River Wall Liaison Summary Note

Stag Brewery

Client Name: Reselton Properties

Document Reference: WIE15582-106-BN-1-2-1-EA

STAG BREWERY, MORTLAKE
 SHIP LANE
 POSSIBLE GROUND PROFILES FOR
 FLOOD DEFENCE MEASURES (SHEET 1 OF 2)

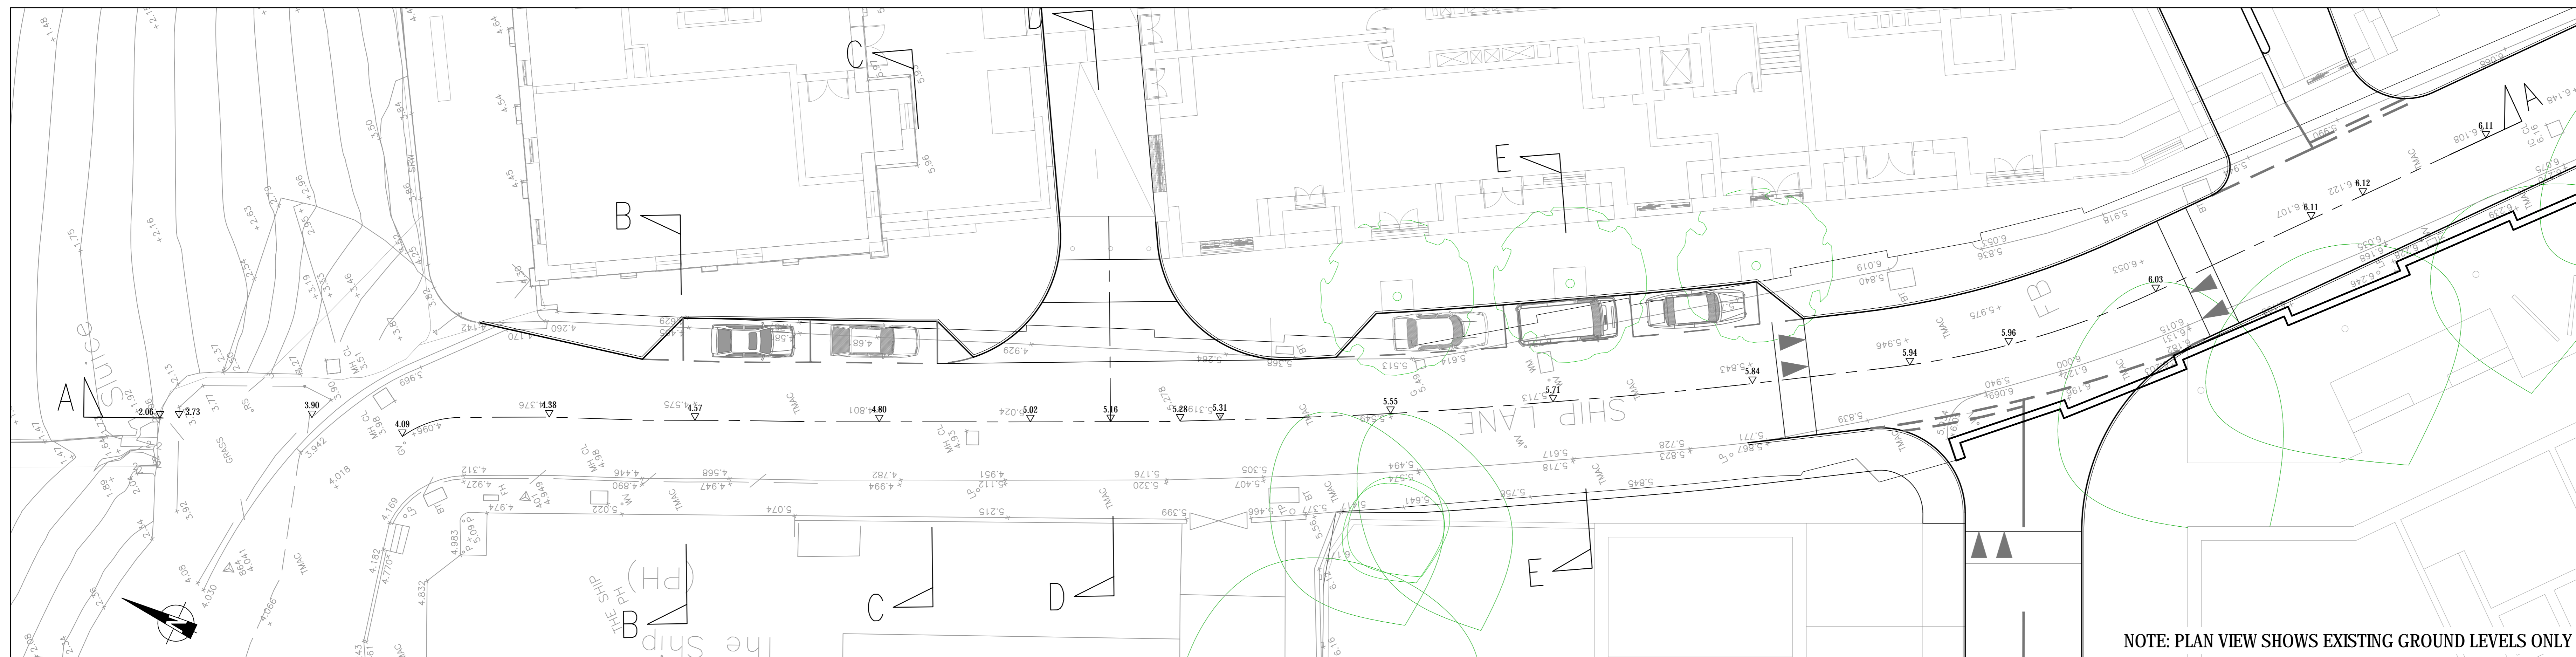
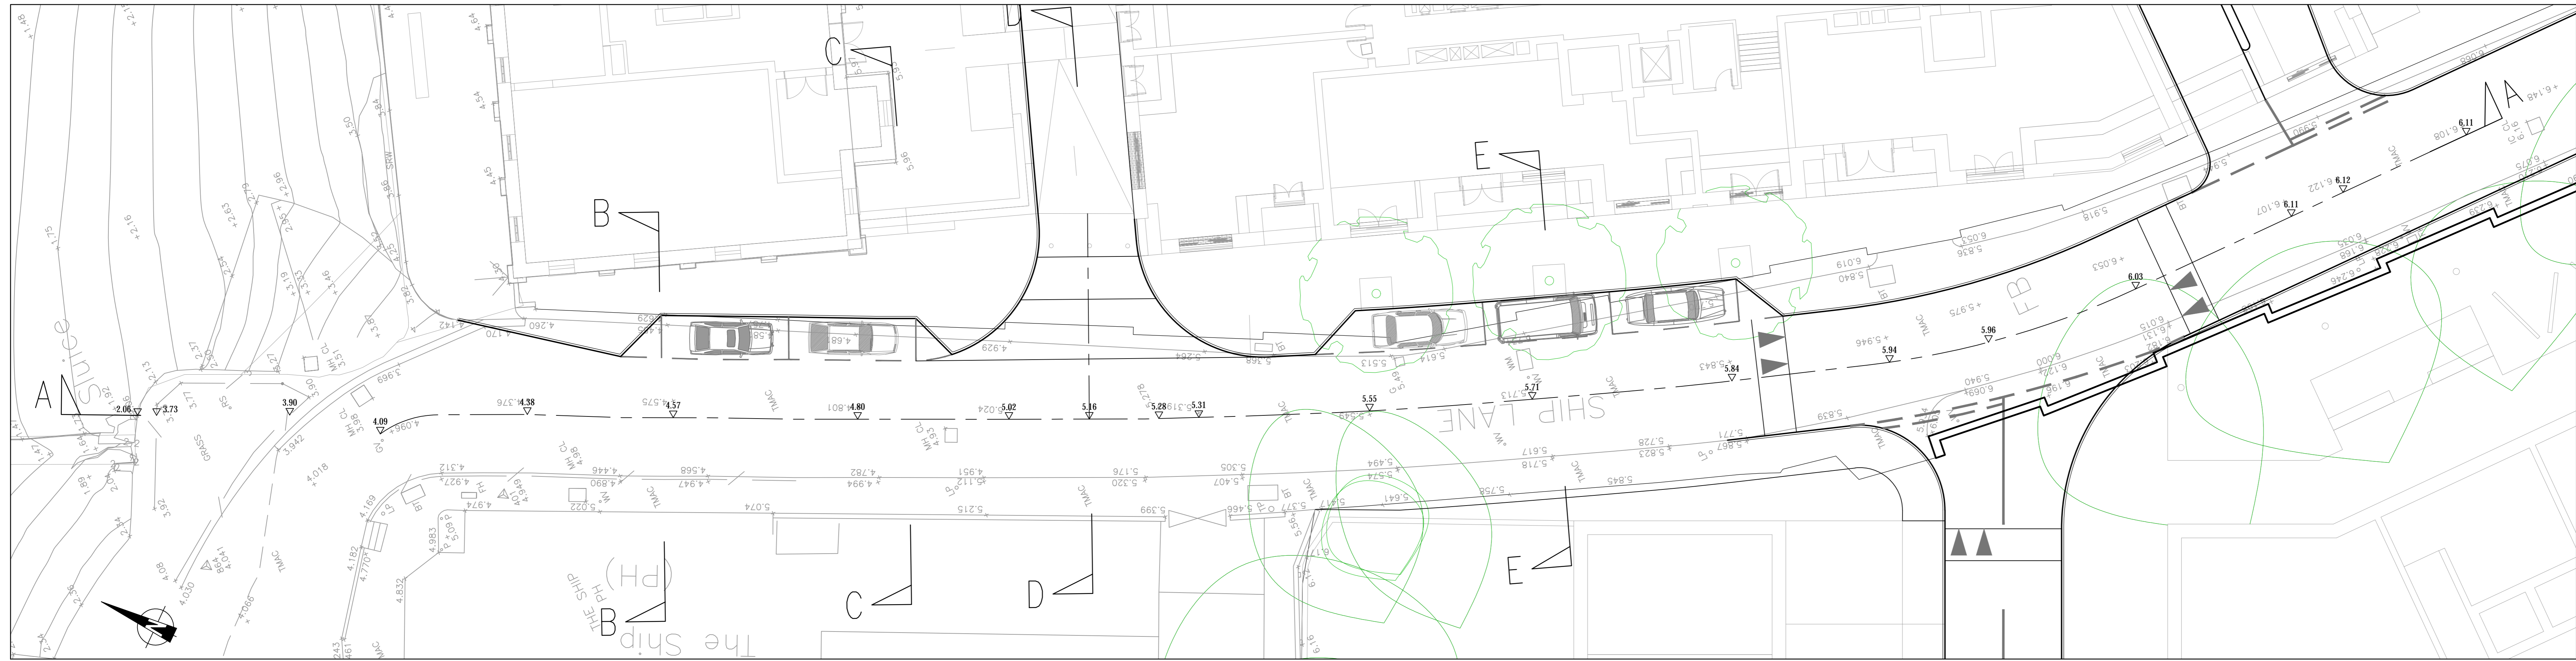
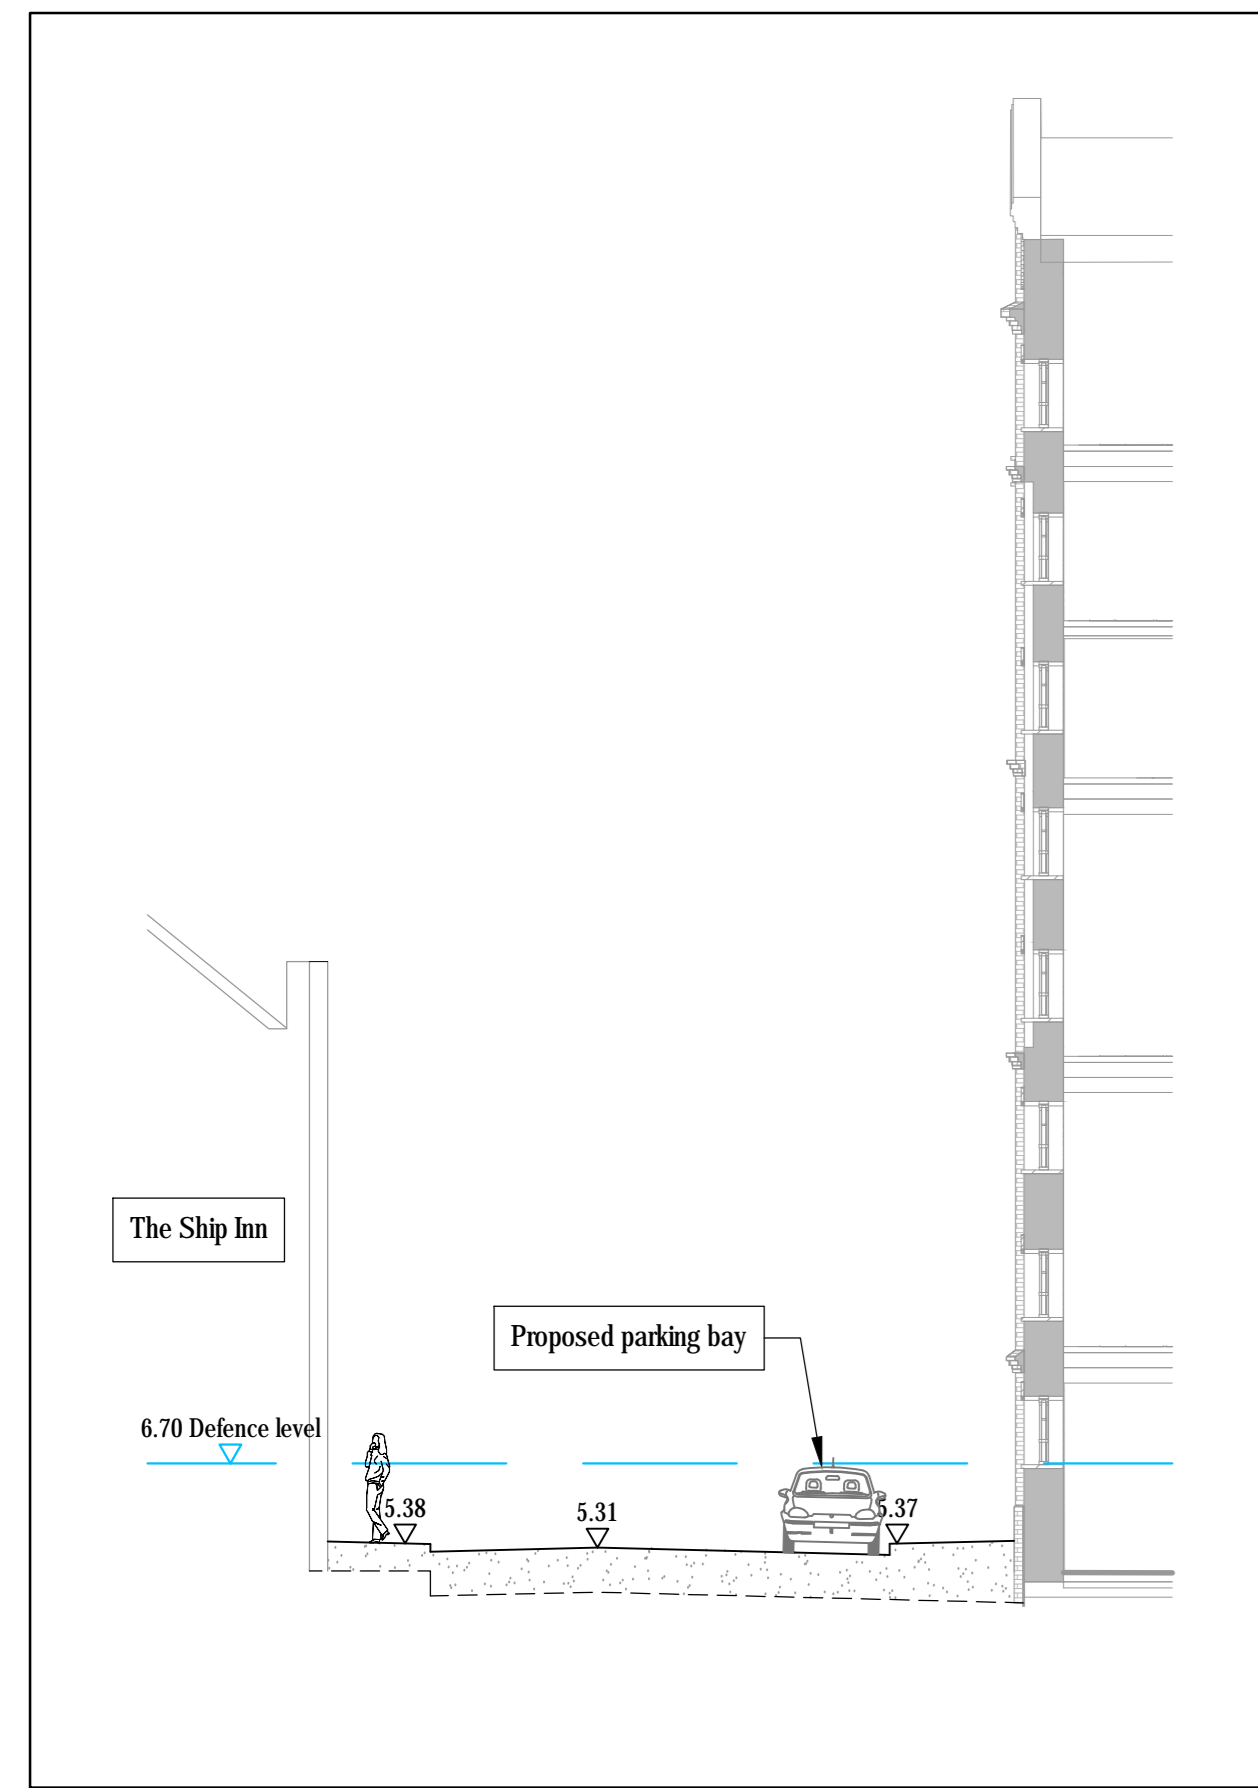
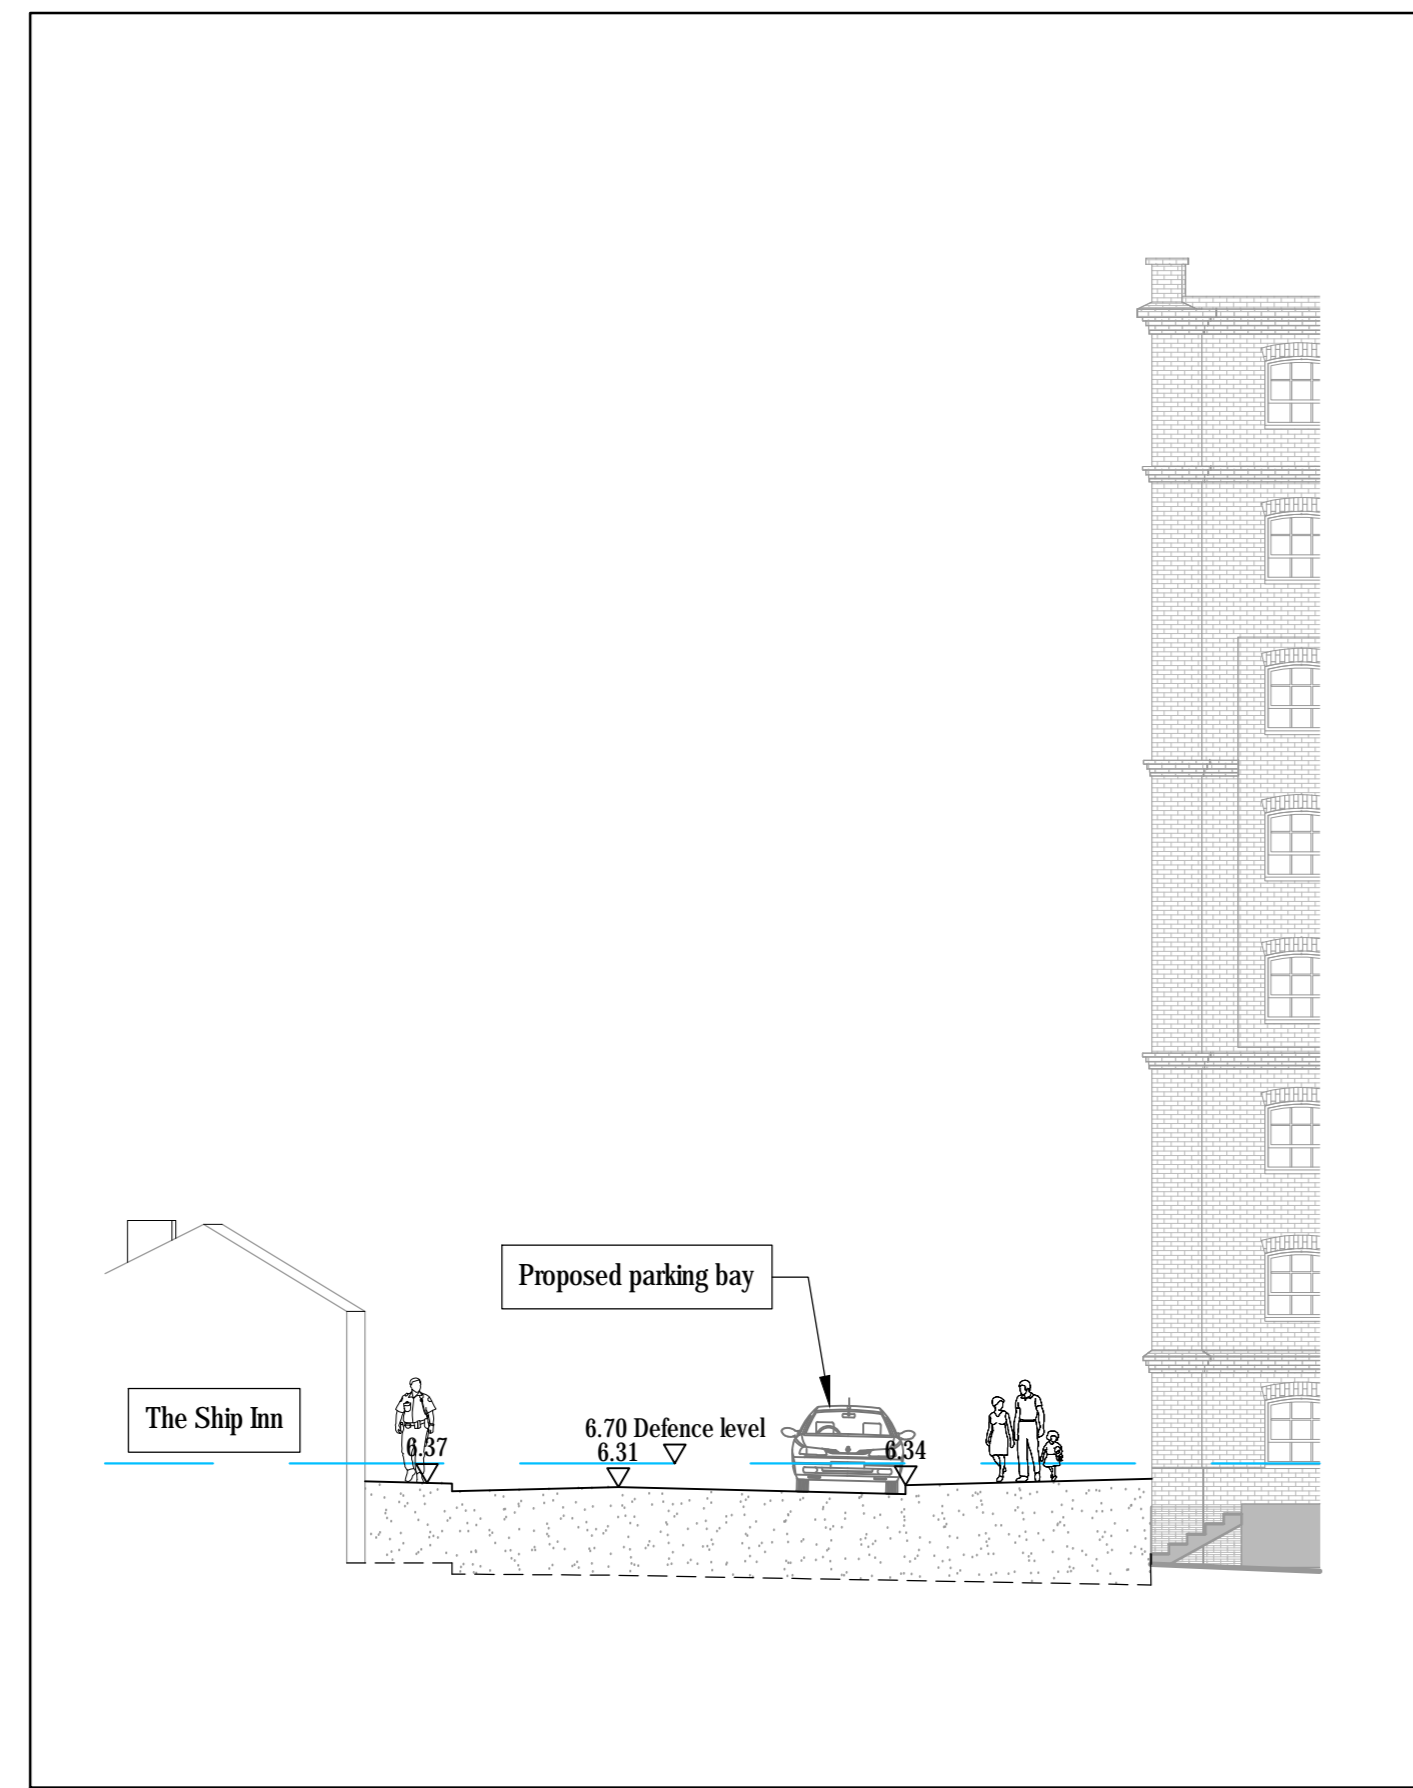
Regarding Ship Lane, we appreciate the applicant may not be the freeholder of this land, and therefore may not be liable to ultimately provide the flood defence across the road. However, the applicant is responsible for demonstrating how all flood defence line within their redline boundary, will be treated in light of TE2100 raising requirements and how these will tie in with the defences on adjacent properties. Developments should not preclude or limit future defence raising options nor should they increase flood risk to neighbouring properties.

- 2.1. As requested by the EA, the team has investigated how a permanent passive flood defence could be incorporated into Ship Lane. As a result, we confirm that in the future it would be possible to raise ground levels on Ship Lane to 6.70m AOD in line with the future requirements of the TE2100 Plan. Drawings provided in Appendix E show how the required ramping would be at a maximum of a 1 in 12 gradient and would not be inhibited by the proposed development (i.e. access would remain achievable with the development in place).
